**Staff Report to the
Municipal Planning Board
January 18, 2022**

**MPL2021-10070
CUP2021-10019
ADDENDUM**

METROWEST WESTGATE APARTMENTS

Site Plan

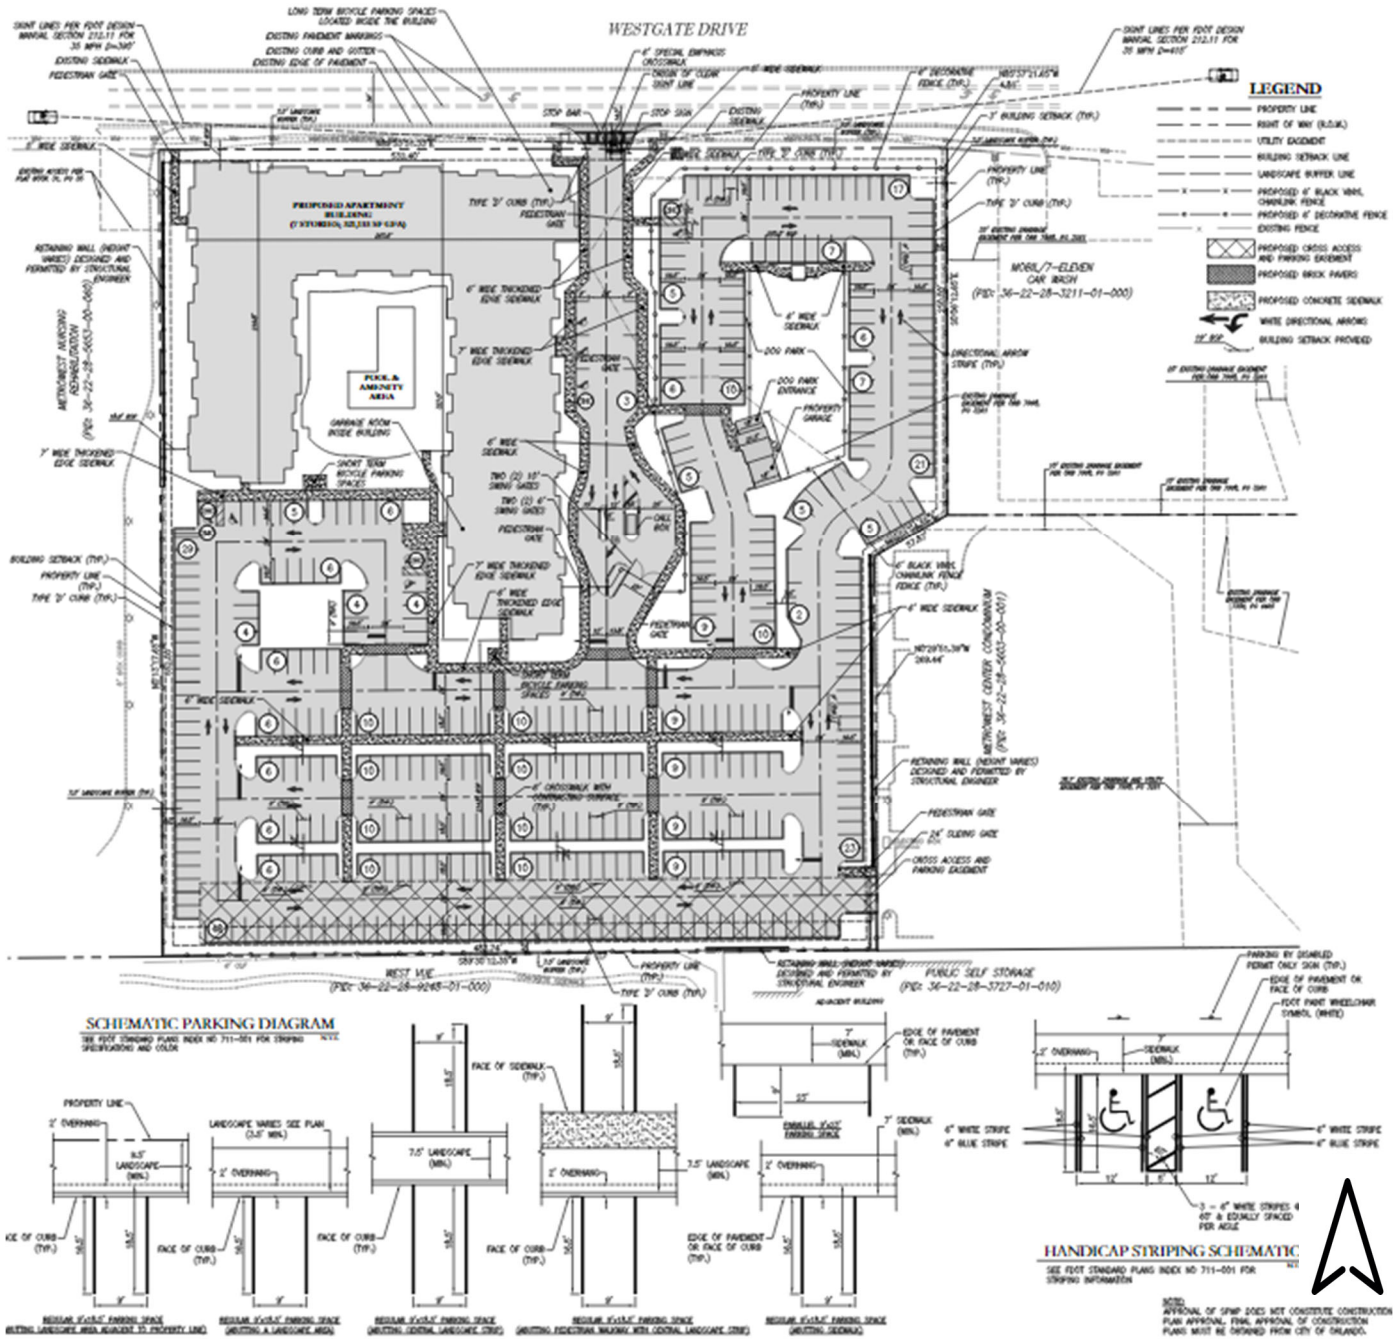
9. Turning Radius: City of Orlando apparatus requires a turning radius dimension of 30 inside and 50 exterior and shall maintain the minimum 20ft. width. An auto-turn analysis is required for the radius turns indicated on the site plan. NFPA 1.18.2.3.5.3.1 and NFPA 1.18.2.3.5.3.2

There is no clearly designated space for garbage and recycling containers in the attached plans.

Elevations

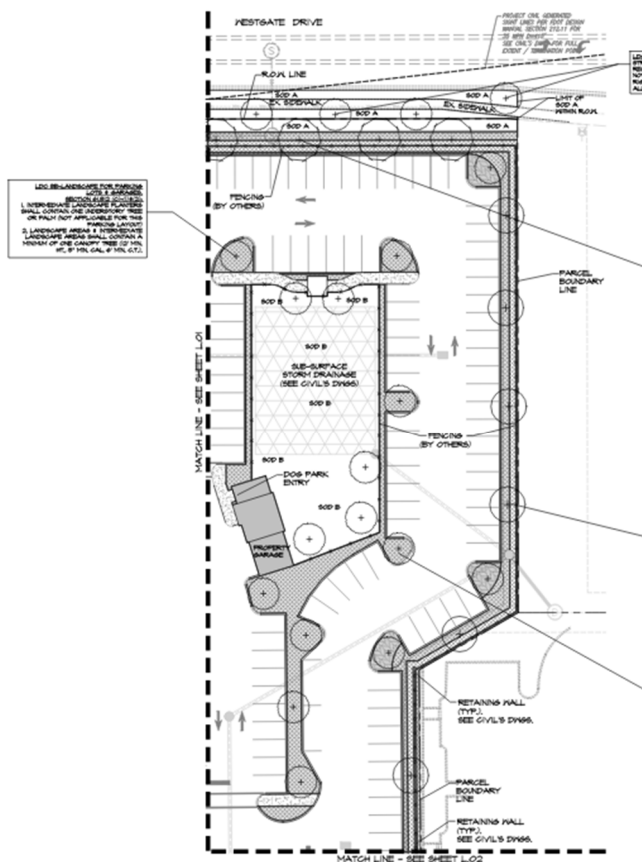
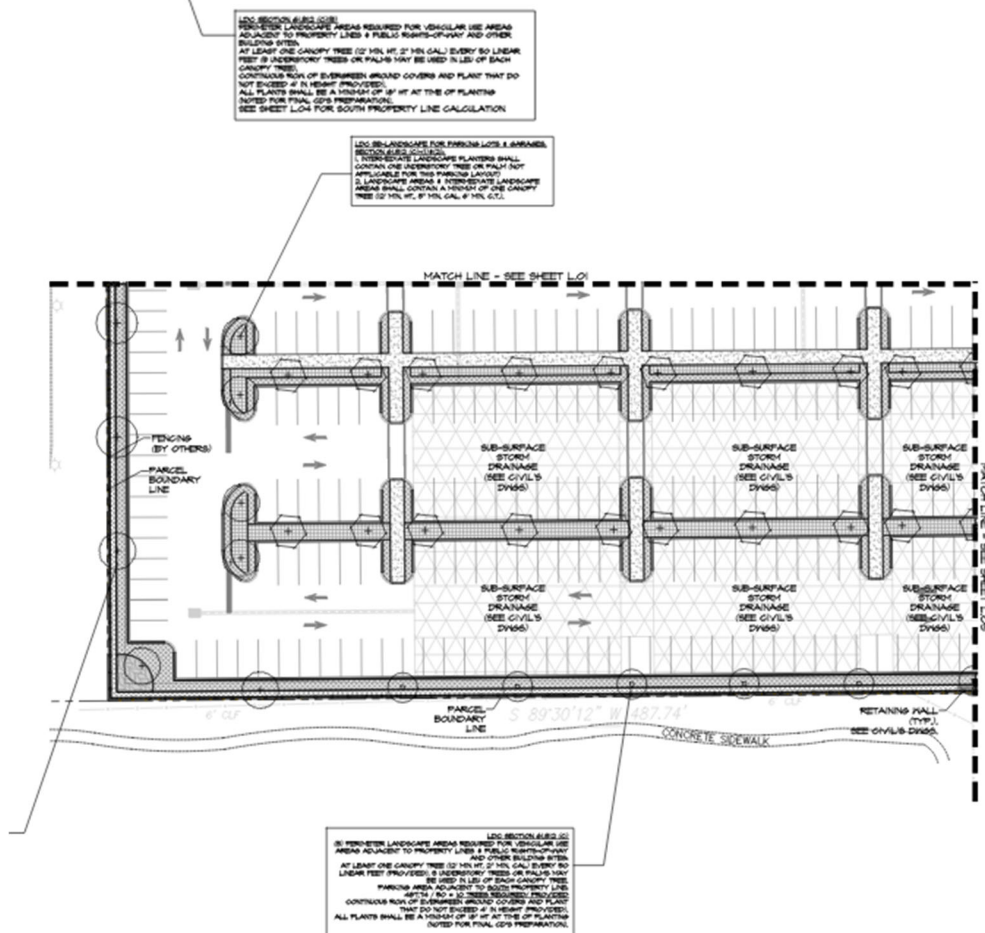
1. A durable base shall be incorporated in the building (ie. no stucco).
 2. No one particular style is dictated over another; however, architecture should be authentic to the style employed.
 3. Primary building pedestrian entries are not clear and must be highlighted through design or materials. More architectural detail and emphasis must be applied on the building to further highlight the pedestrian entries. The guidelines listed below must be applied.
 - Increasing the height of the façade wall at the pedestrian entry area(s)
 - Add a stone/decorative detail at the base of the building
 - Add a metal canopy structure over the first floor entry that complements the architecture and style of the building
 4. All projecting parapet walls must wrap a minimum depth of 5 ft. or more whichever is proportionate to the parapet wall, in efforts for the projecting parapet walls to appear 3D.
-
